West Torrisdale Wind Farm

Additional Information Report

August 2025

Figure 1: Derived Night Limit – Lephincorrach Cottage

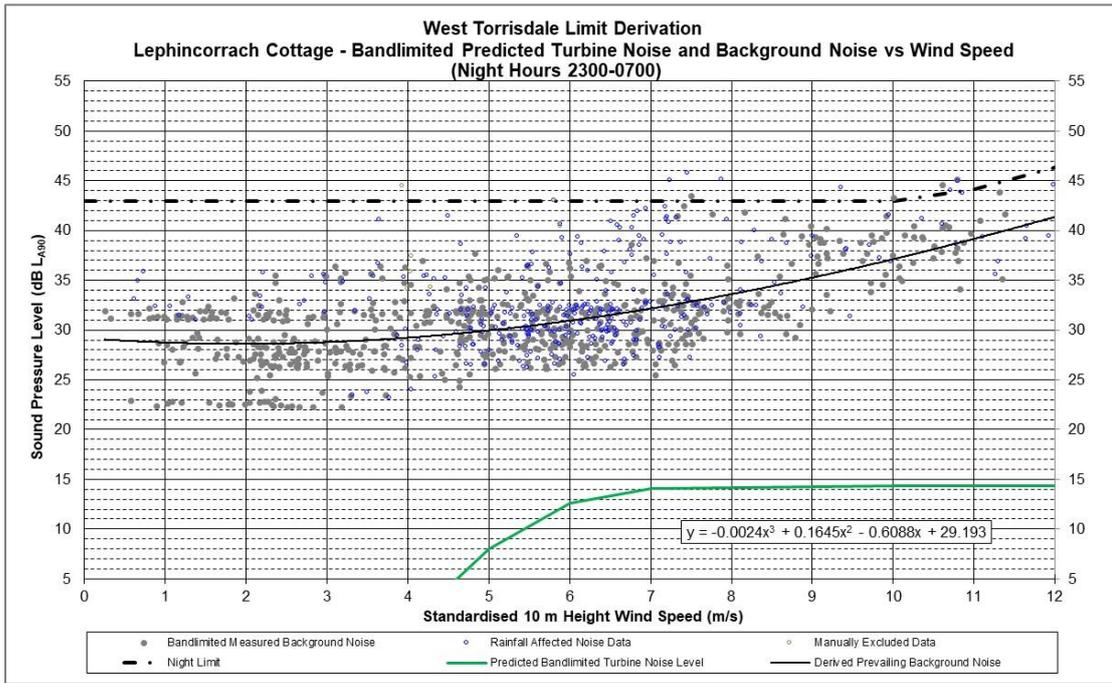
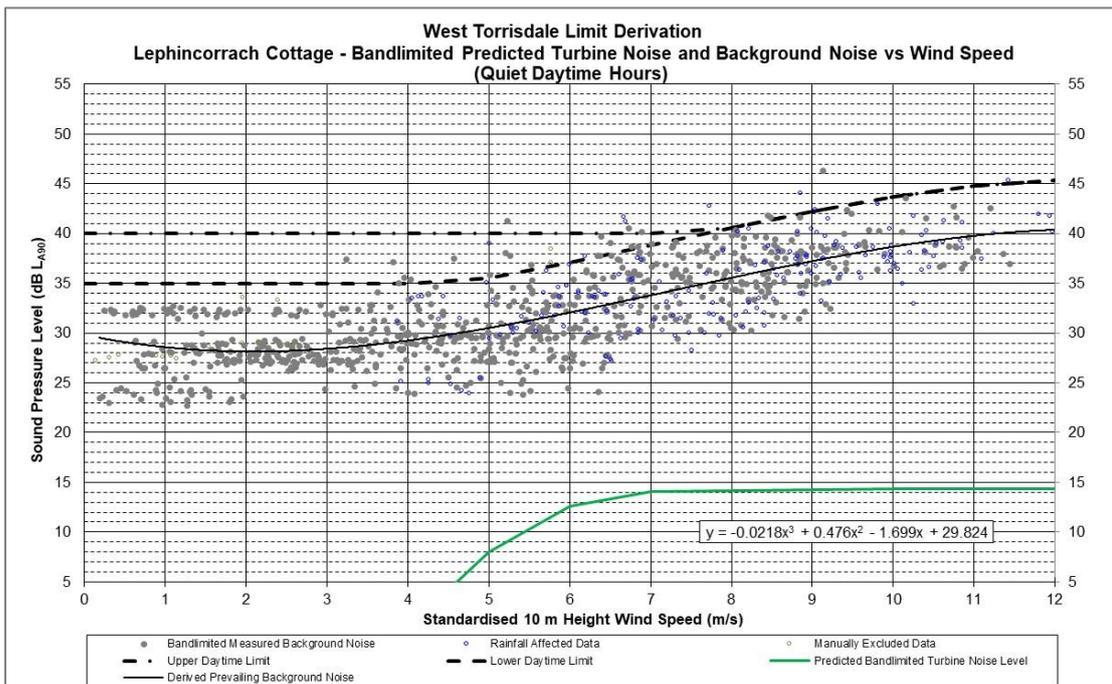
Consultee and Date	Consultee Response	Response
Argyll and Bute Council 1 May 2025	Argyll and Bute Council commissioned a review, carried out by Mott MacDonald, of the noise assessment presented in the EIAR, which was summarised in a report dated March 2025. In the Executive Summary of the Mott MacDonald Report it is noted that: <i>"The measured background noise levels that are relied upon by the Applicant relied to inform the noise limits should be reprocessed (in accordance with Institute of Acoustics Good Practice Guide) to eliminate the influence of the Beinn an Tuirc wind farm and its extensions, which operational at the time of the survey."</i>	Further information is provided at Section 7.3 below. The reanalysis of the noise survey data provides a conservative assessment of the measured data which excludes the possibility of contribution from the Beinn an Tuirc Wind Farm and its extensions.

- 7.3.12 **Figure 1** and **Figure 2** below represent updates to Figure 7 and Figure 8 from Technical Appendix 11.1, Volume 4 of the EIAR. These figures show the band-limited datasets of background noise (800 Hz to 20 kHz) plotted against wind speed for Lephincorrach Cottage and the band-limited predictions for existing turbine noise at this location. It can be seen that the predicted band-limited turbine noise level is more than 15 dB below derived prevailing background noise, and therefore the contribution from existing turbine noise is negligible.

7.3.13 At Lephincorrach Cottage, the updated night noise limits are slightly lower than those presented in the EIAR for wind speeds of 10 m/s and above. The updated lower daytime noise limit is roughly 2 dB below the limit presented in the EIAR for wind speeds of 4 to 11 m/s and equal to or below the EIAR limits for all other wind speeds.

Figure 3: Derived Night Limit – Ifferdale

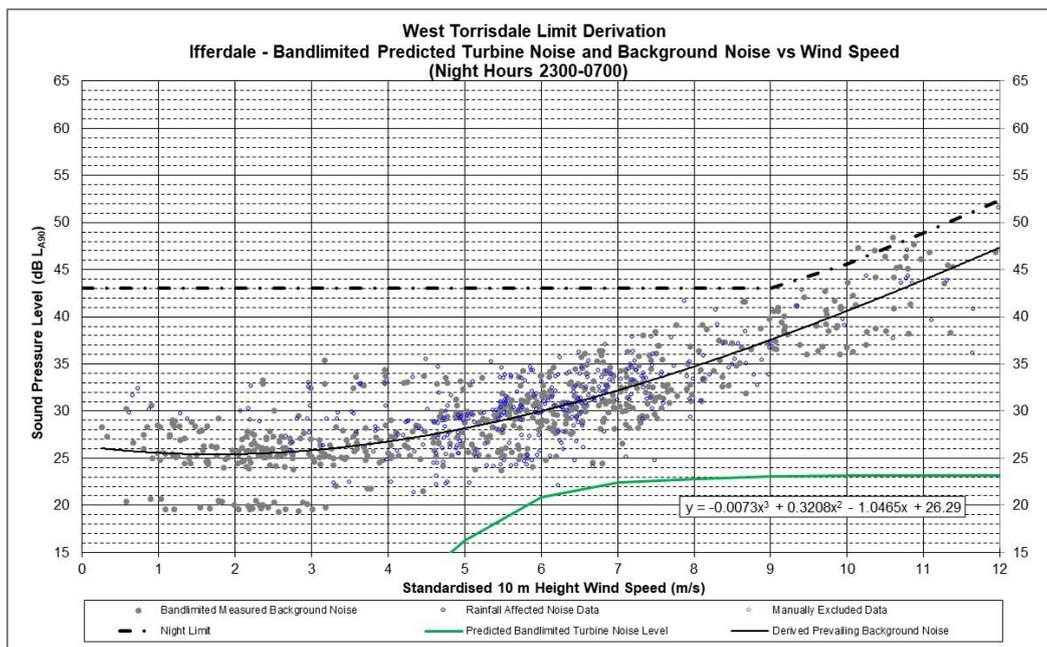
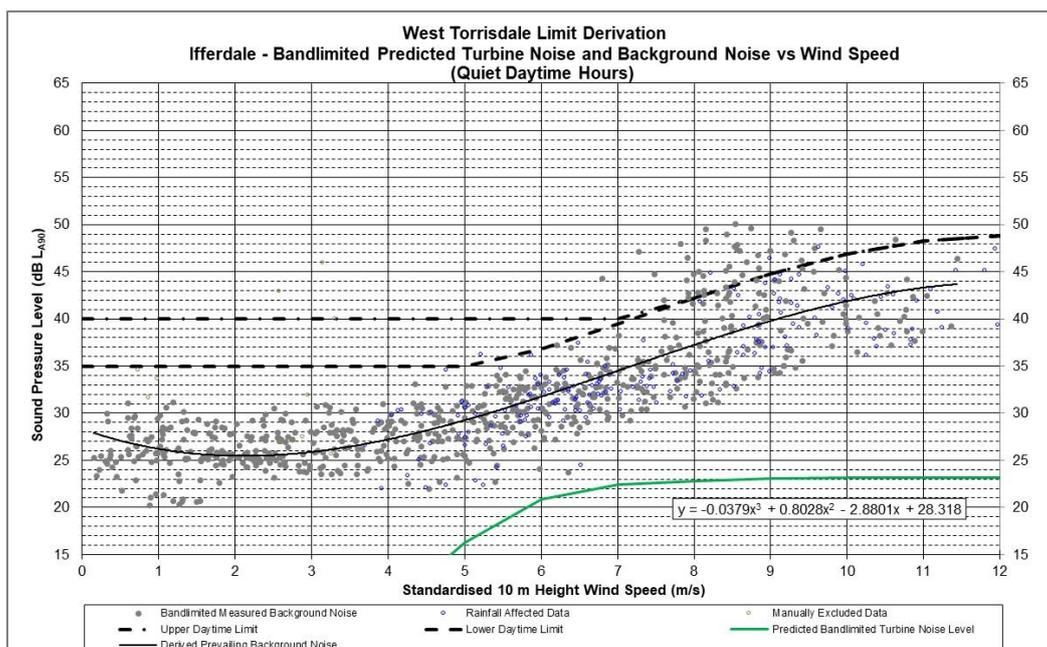
7.3.14 **Figure 3** and **Figure 4** below represent updates to Figure 9 and Figure 10 from Technical Appendix 11.1, Volume 4 of the EIAR. These figures show the band-limited datasets of background noise (800 Hz to 20 kHz) plotted against wind speed for Ifferdale and the band-limited predictions for existing turbine noise at this location. It can be seen that the predicted band-limited turbine noise level is 7 dB or more below derived prevailing background noise at night and 11 dB or more below derived prevailing background noise during the day, and it is considered that the contribution from existing turbine noise is negligible.

7.3.15 At this location, the updated night noise limits are lower than those presented in the EIAR by up to 2 dB for wind speeds above 9 m/s. The updated lower daytime noise limit is below the limit presented in the EIAR by up to 3 dB for wind speeds above 5 m/s.

Figure 5: Derived Night Limit – Glen Croft

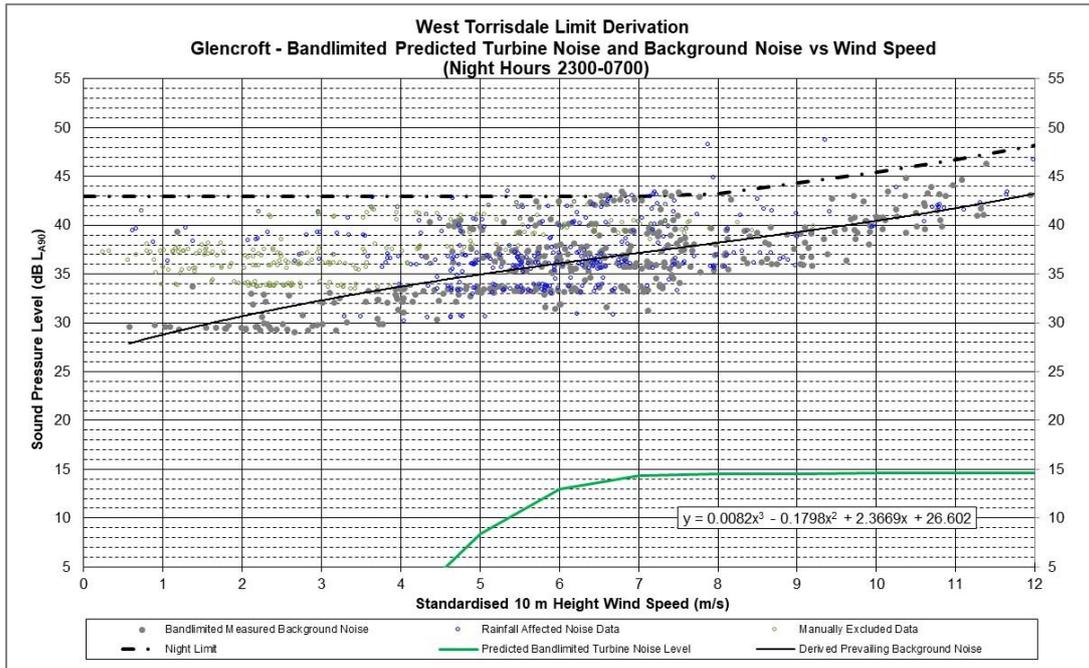
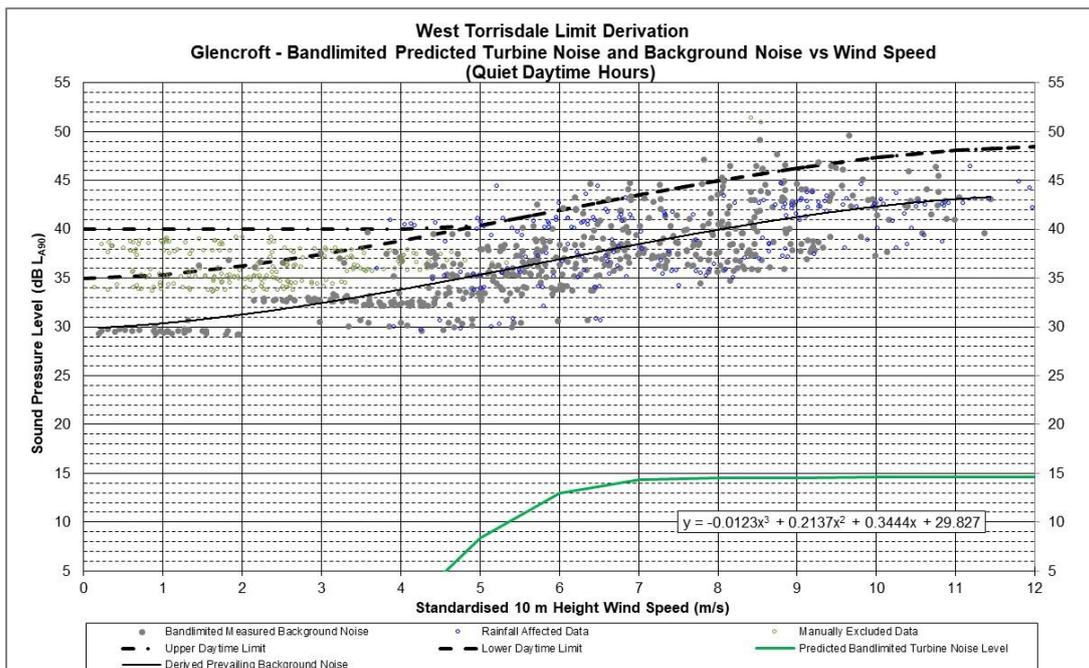
7.3.16 **Figure 5** and **Figure 6** below represent updates to Figure 11 and Figure 12 from Technical Appendix 11.1, Volume 4 of the EIAR. These figures show the band-limited datasets of background noise (800 Hz to 20 kHz) plotted against wind speed for Glen Croft and the band-limited predictions for existing turbine noise at this location. It can be seen that the predicted band-limited turbine noise level is more than 20 dB below derived prevailing background noise, and therefore the contribution from existing turbine noise is negligible.

7.3.17 At this location, the updated night noise limits are lower than those presented in the EIAR by up to 2 dB for wind speeds of 7 m/s and above. The updated lower daytime noise limit is below the limit presented in the EIAR for all wind speeds by 1 – 2 dB.
